RE: 41-49 (BOOKERS) AND 49-59 (FORMER BMW) BATTERSEA PARK ROAD – DAYLIGHT AND SUNLIGHT STATEMENT

Glenn Howells Architects ('GHA') have made an amendment to the design of Plot 01 Level 11 to respond to additional requirements for the wheelchair adaptable apartments. This has resulted in the removal of inset balconies at Level 11 and their replacement with projecting balconies to replicate the condition from Levels 04-10. The image below was prepared by GHA and illustrates the proposed design amends:

Plot 01 Level 11 Proposed Plan showing proposed balcony amendments (Source: Glenn Howells Architects)

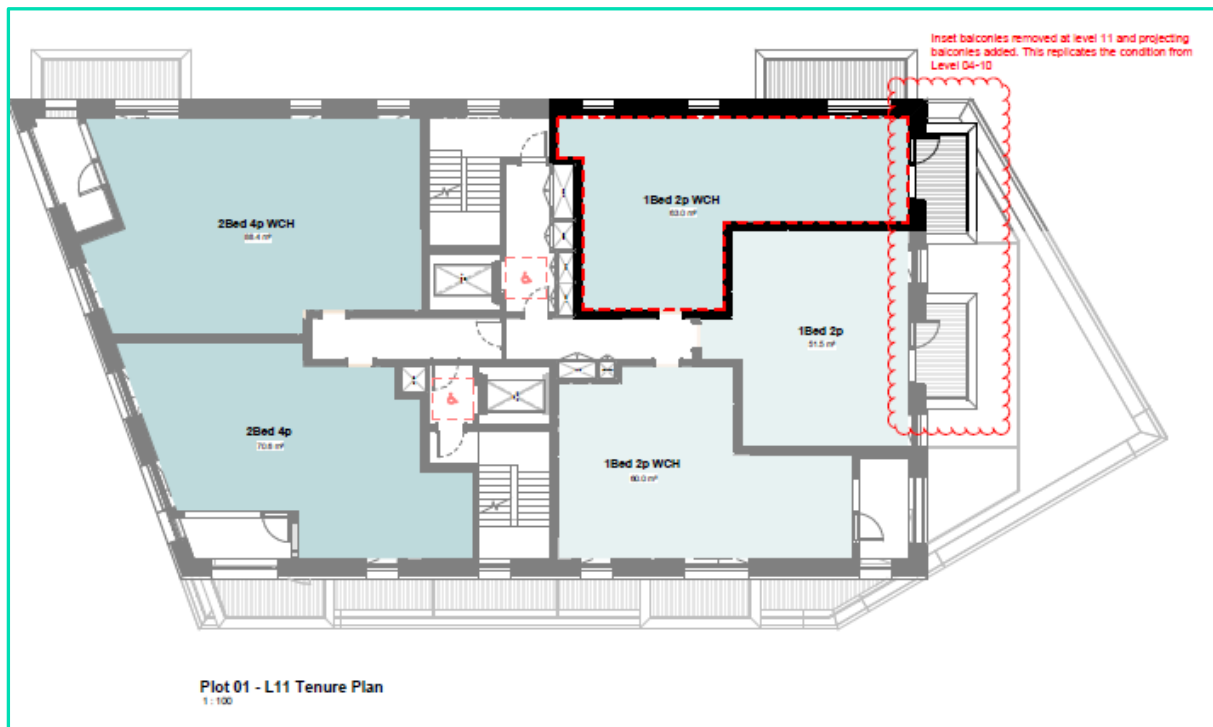
On the basis of the minor amendments proposed to the balcony design at Level 11, the overall building envelope of Plot 01 is not going to materially increase in profile such that in our professional opinion the design amendments will have no discernible effect on the daylight, sunlight and overshadowing amenity to external neighbouring buildings.

In regard to the quality of natural daylight/sunlight amenity within the Proposed Development itself, and in particular Plot 01, there are two considerations worth noting. Firstly, the introduction of projecting balconies rather than inset balconies is likely to serve to further improve the internal daylight and sunlight provision to the associated apartments at Level 11 when compared to the Submitted Scheme. This is because the windows serving the projecting balconies will now be located on the outer face of the elevation, rather than inset within the building façade, allowing them greater access to available sky.

Secondly, in respect of the apartments located at Level 10, and in particular those with windows located directly beneath the now proposed projecting balconies at Level 11, the introduction of projecting balconies does, in theory at least, have the potential to have an effect on the internal daylight/sunlight levels. However, from a review of the internal daylight and sunlight assessment results for Submitted Scheme, the rooms in question were all achieving internal daylight/sunlight levels well in excess of the BRE recommendations. Therefore, given the elevated position of these particular flats, in our professional opinion the proposed design amendments will have no material bearing on the quality of natural light amenity to these apartments and should continue to exceed the internal daylight levels of the corresponding BRE compliant rooms recorded below at Level 09.

In conclusion, it is our view that the minor design amendments to Plot 01 Level 11 are unlikely to have any material bearing on the daylight, sunlight and overshadowing to neighbouring properties, nor should they have any discernible effect upon the quality of natural light amenity to the proposed accommodation. The conclusions of the Point 2 Daylight, Sunlight and Overshadowing Report submitted alongside the planning application for the Submitted Scheme should therefore remain unchanged.
